BREA Technologies, Inc.
14902 Mesita Drive
Houston, TX 77083-3209
P: (281) 530-3063
F: (281) 988-0358
BillG@breatech.com

To: T10 Technical Committee
From: Bill Galloway
Subj: SAS Credit Not Ready

A new primitive is needed to allow the recipient of frames to say that it does not have anymore credit and will not have any credit anytime soon.

Figure 1. SSP link layer state machines (part 1 - frame transmission)

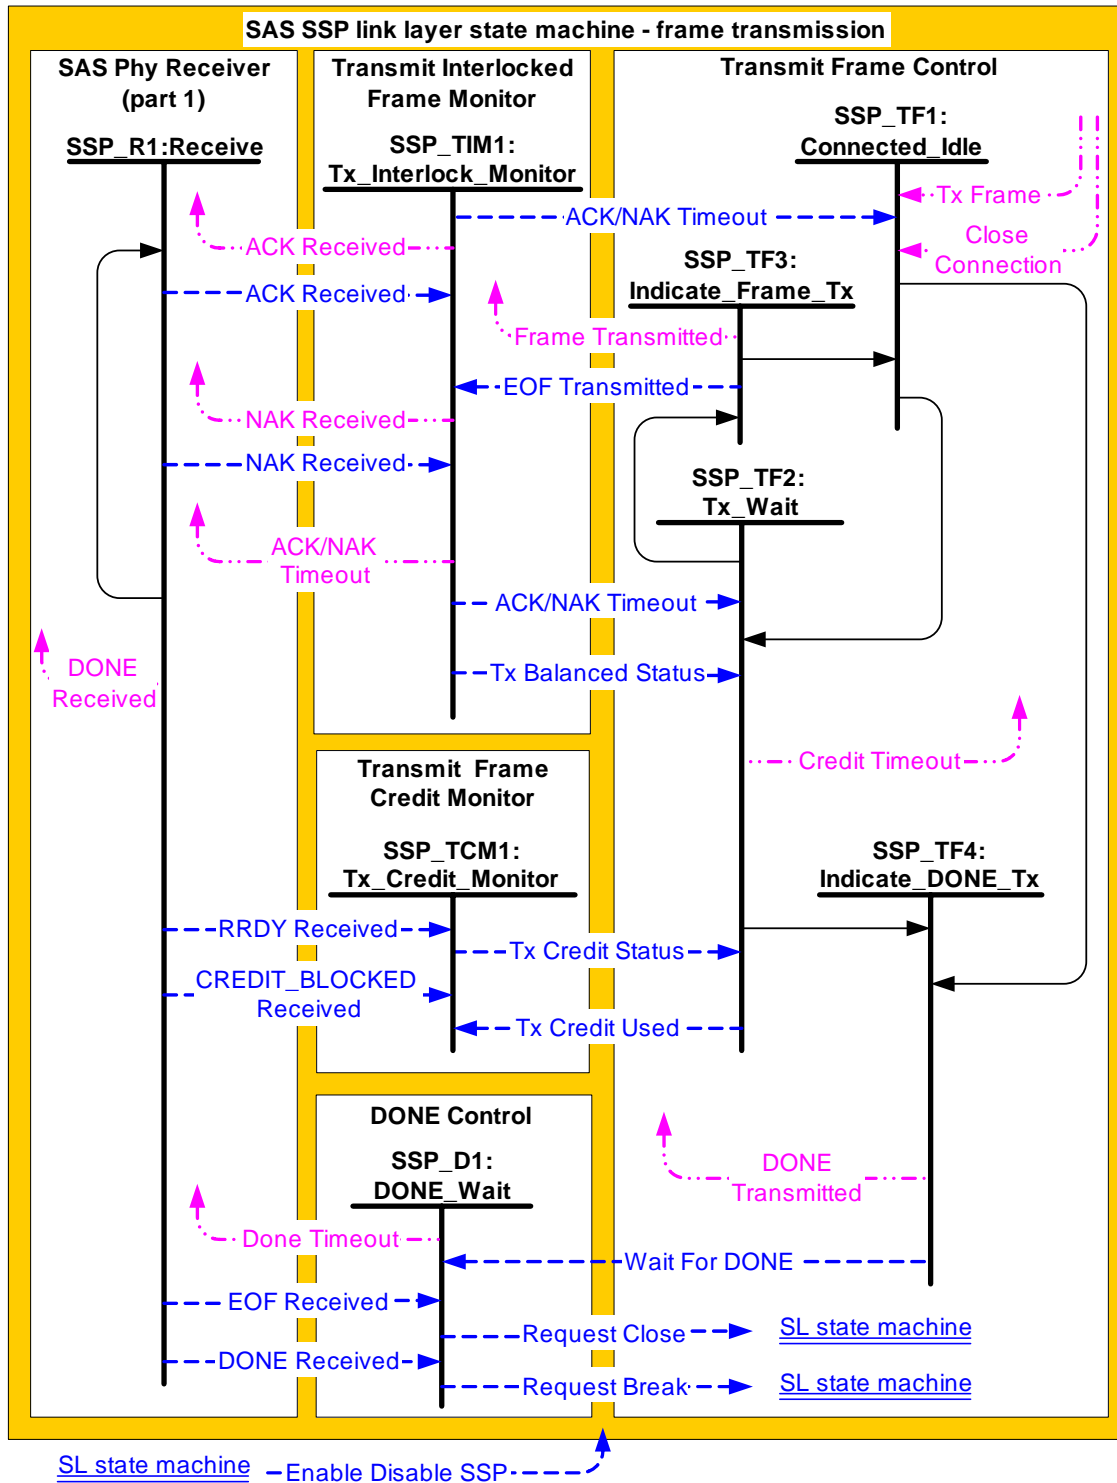
Update state diagrams with new parameters.

Figure 1 shows the states related to frame transmission.

Figure 2. SSP link layer state machines (part 2 - frame reception)

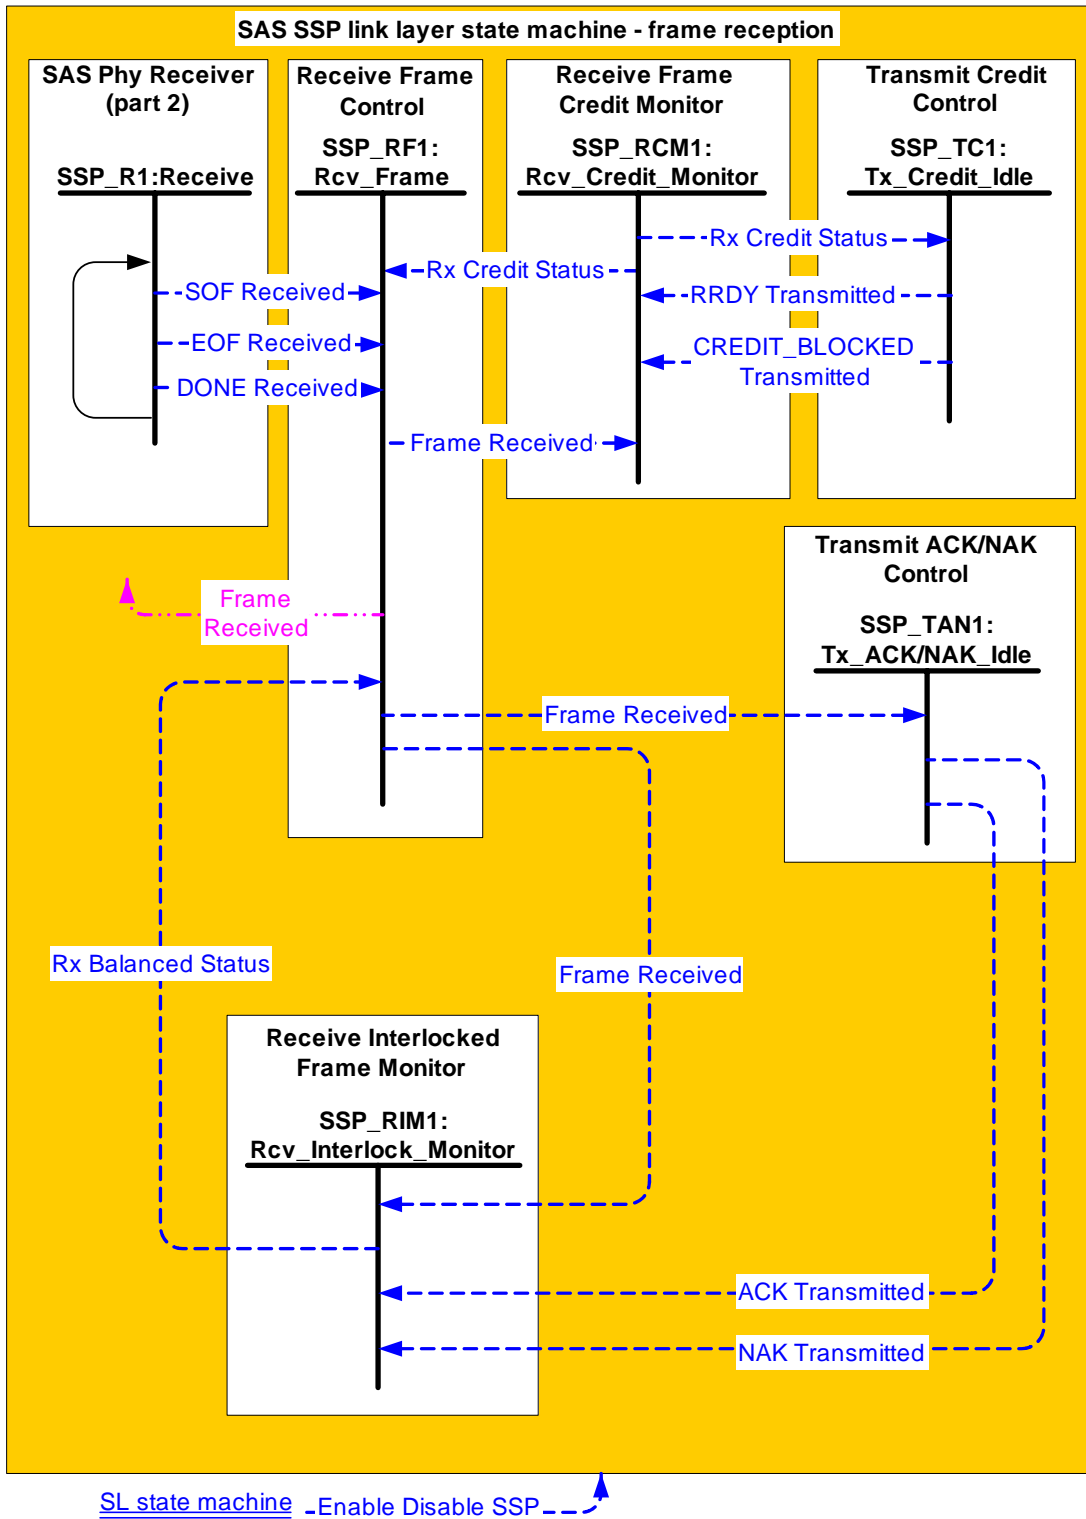
Figure 2 shows the states related to frame reception.

Figure 3. SSP link layer state machines (part 3 - primitive transmission)

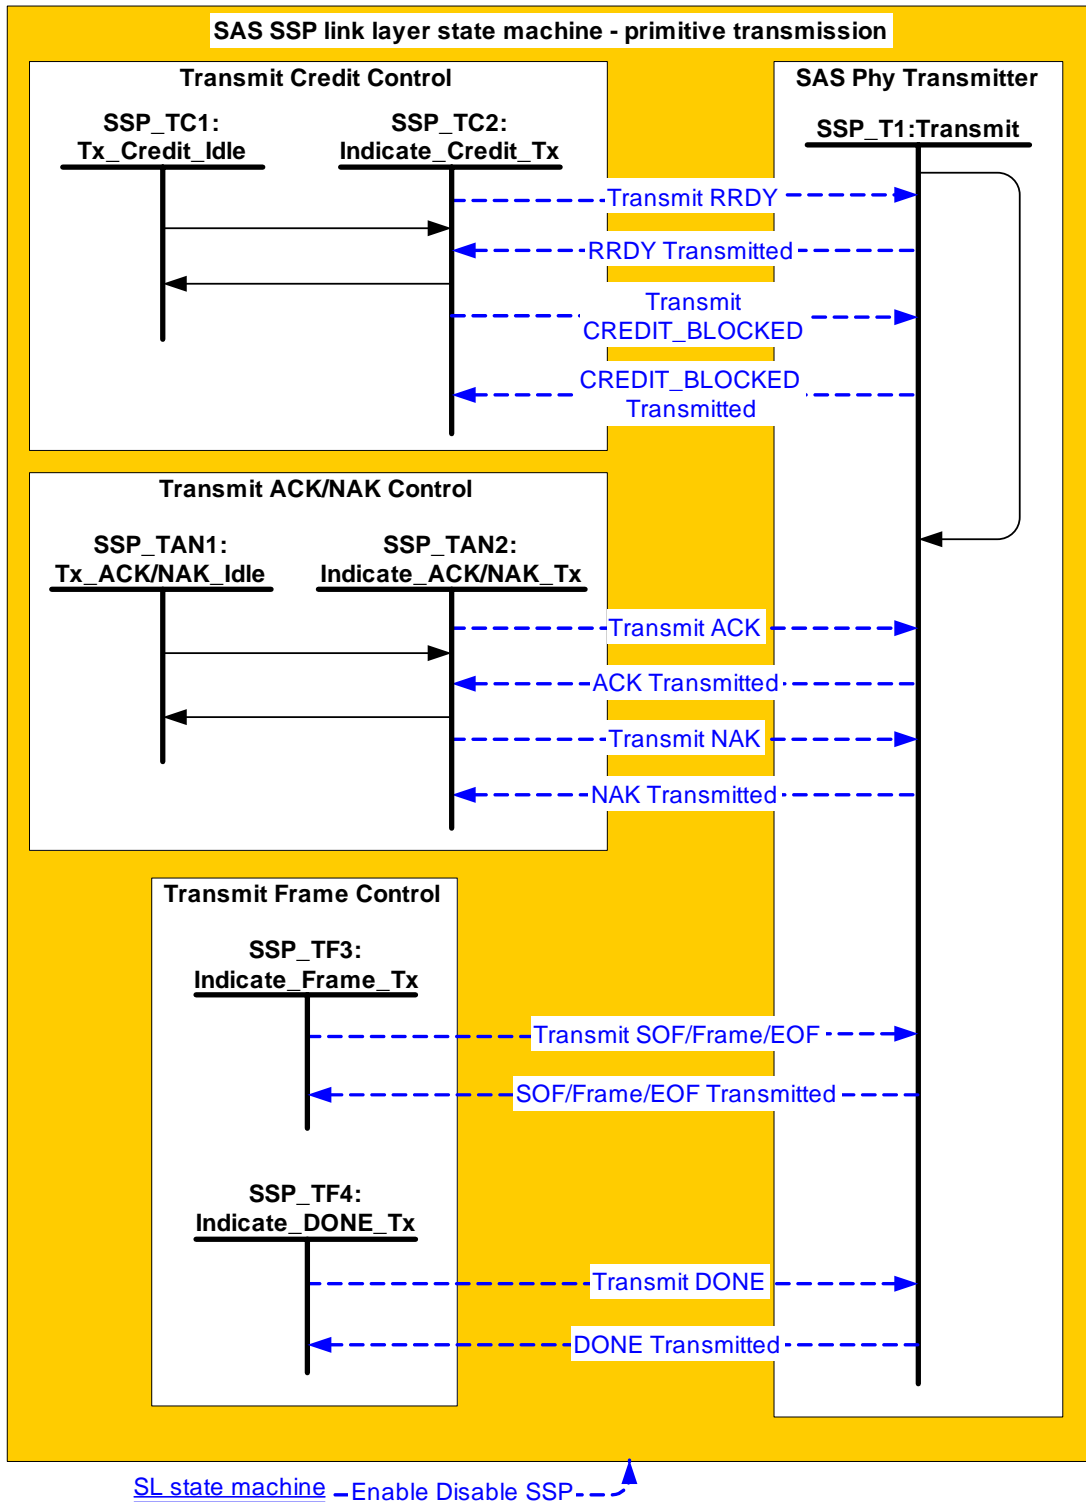
Figure 3 shows the states related to primitive transmission.

The SSP_TC state machine's function is to control when the SSP_T state machine transmits an RRDY or CREDIT_BLOCKED. The SSP_TC state machine contains the following states:
